RE: Request for a TEDS Exception for the Human Bean Coffee Drive through at 1430 North Avenue

RE: An Addendum to a request for a TEDS Exception for the Human Bean Coffee Drive through at 1430 North Avenue

Design Exception #36-06, Human Bean Coffee Drive Through – 1430 North Avenue
TEDS Exceptions for Access Location and Stacking

DESIGN EXCEPTION #36-06

Human Bean Coffee

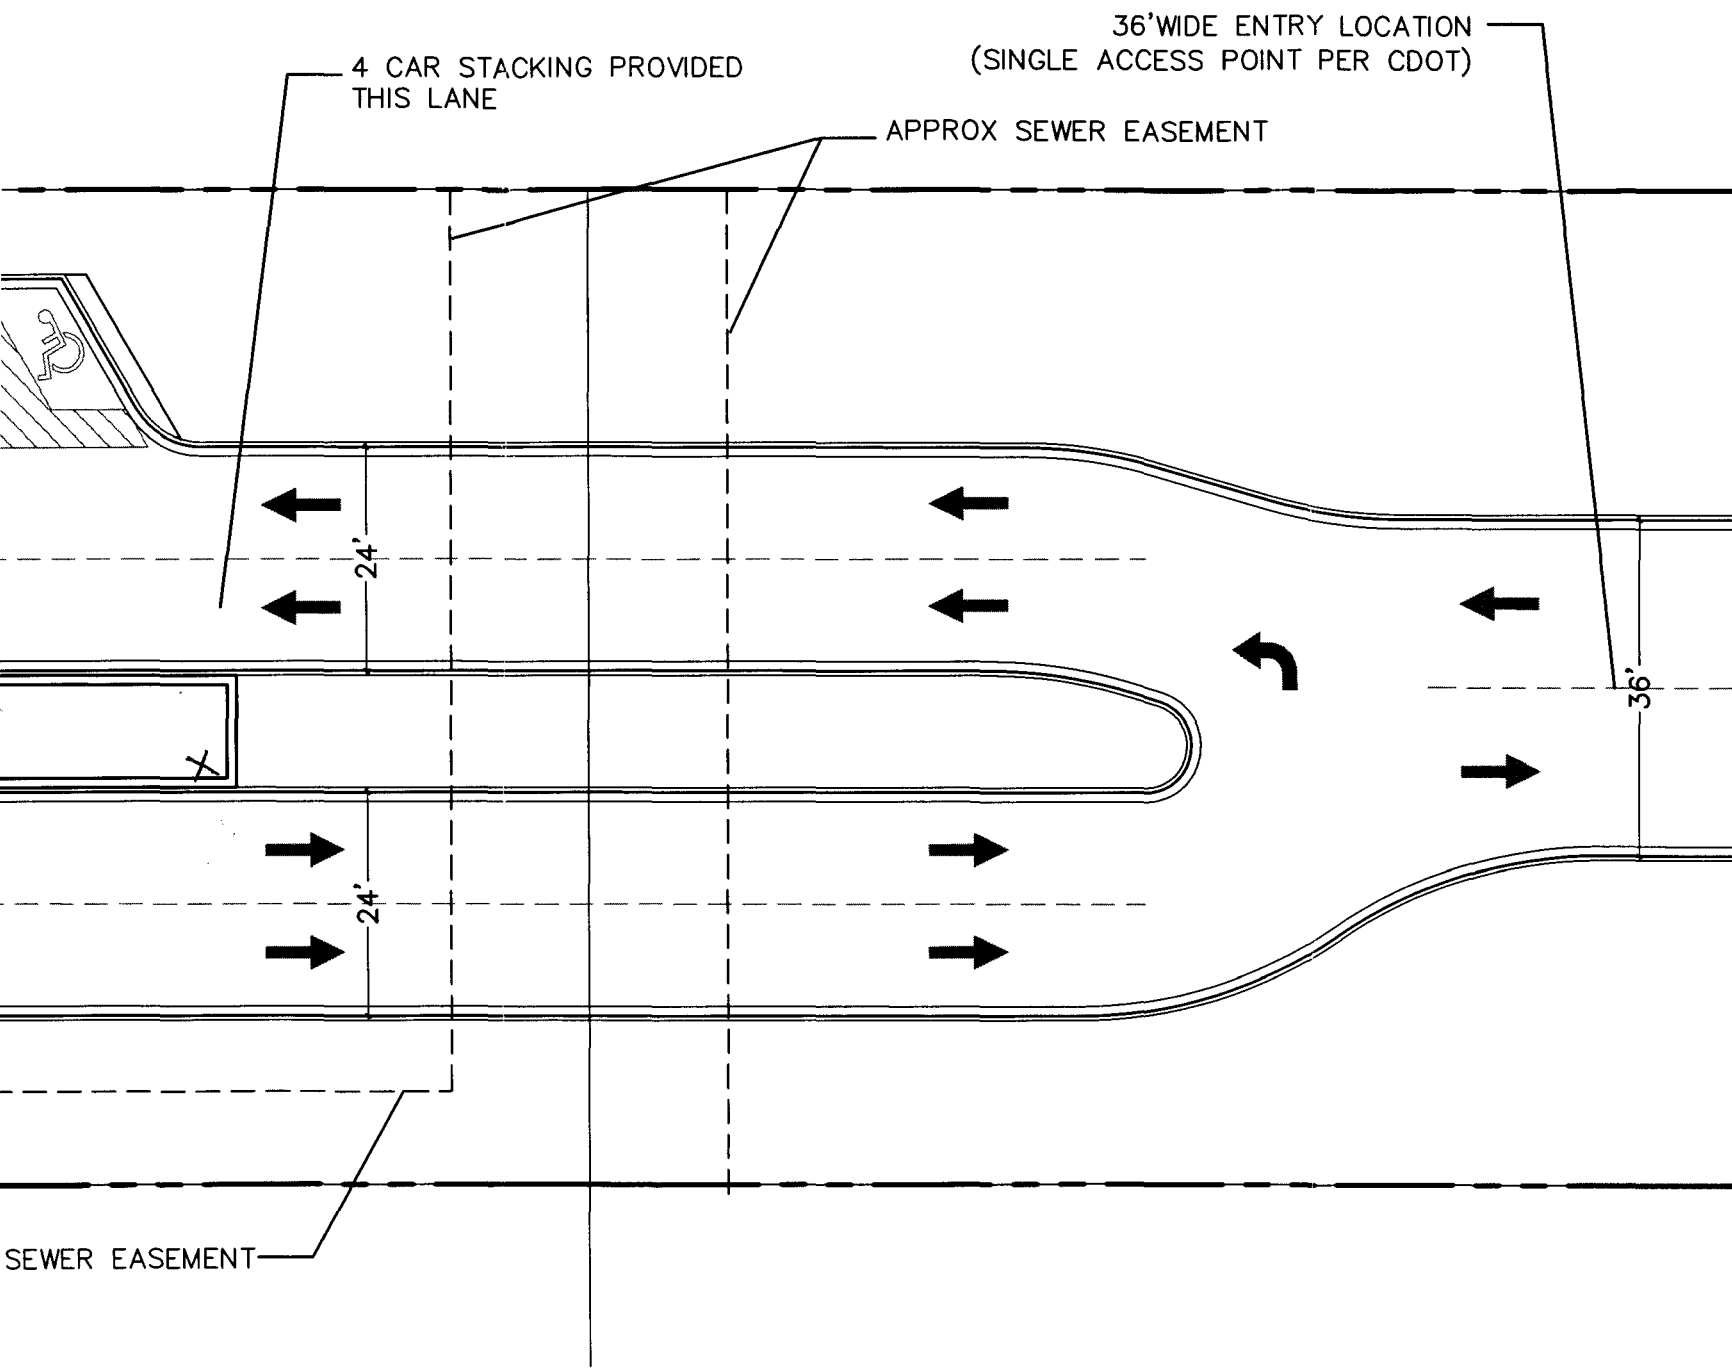
The applicant proposes a primary right-in / right-out access point off of North Avenue and a secondary access point off of Glenwood Avenue. The North Avenue access point will be approximately 125 feet centerline to centerline from the Pizza Hut (1440 North Avenue) driveway. The North Avenue access point will be approximately 150' feet centerline to centerline from nearest driveway west of the project. There is an existing median in North Avenue limiting the site to right-in / right-out access only on North Avenue.

The applicant is requesting that the city approve a stacking distance of 4 vehicles lengths per drive up window bay by allowing an exception to TEDS *Section 4.2.5.2 Commercial Uses* as follows:

The applicant has historic data from many Human Bean Coffee shops located in Colorado that indicate 4 vehicle lengths is sufficient for the stacking needs of each window. The applicant would also like to reference the existing coffee drive-through uses at the corner of North Avenue and 7th Street. These uses do not appear to have the required 10 vehicle stacking spaces per window as required by code. We would request that you treat this identical use within those previously adopted parameters.

#1 Access to North Avenue: The proposed access location on North Avenue violates two sections of TEDS: 3.2.2 Provision of Access (access from the lower order street) and TEDS 4.1.1 Spacing (less than 150' from adjacent driveways) being approximately 85' from the edge of the Pizza Hut driveway.

#2 Vehicle Stacking to Drive-Up Window (Fast-Food Restaurant): TEDS 4.2.5.2 lists specific uses and their required stacking lengths. The use that most closely matches the proposed use is Fast Food Restaurant – however it does not seem that the use necessarily would have the intense demands of a fast food restaurant. The applicant' representative has stated that similar stores on the Front Range and other location have a traffic demand of 30 vehicles per hour in AM Peak hour and their current stacking requirements 4 vehicles per window. This stacking is in addition to provided parking and on-site circulation.

Staff recommends approval of the exceptions as requested with the following modifications:

- a). The applicants execute a cross-access easement across the front 60' of the parcel in event that one or both neighboring parcels redevelop.
- b). The applicants final site plan demonstrate that adequate on-site circulation be provided in addition to stacking.

c). The applicant submits a signing : PAVEMENT MARKING PLAN.
